Addendum 6 – Regulation No. 7

Revision 2 – Amendment 1

Supplement 2 to the 02 series of amendments
Date of entry into force: 26 January 1994

UNIFORM PROVISIONS CONCERNING THE APPROVAL OF FRONT AND REAR POSITION
(SIDE) LAMPS, STOP-LAMPS AND END-OUTLINE MARKER LAMPS FOR MOTOR VEHICLES
(EXCEPT MOTOR CYCLES) AND THEIR TRAILERS

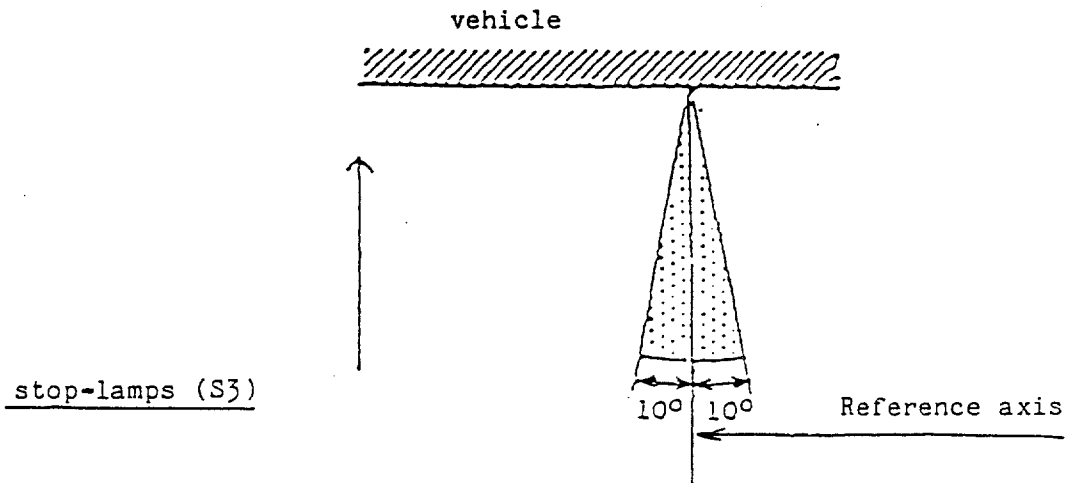
In the figure "Minimum horizontal angles of light distribution in space," amend the title of the third diagram "Stop lamps" to read "Stop lamps (S1 and S2)" and add a new fourth diagram to read:
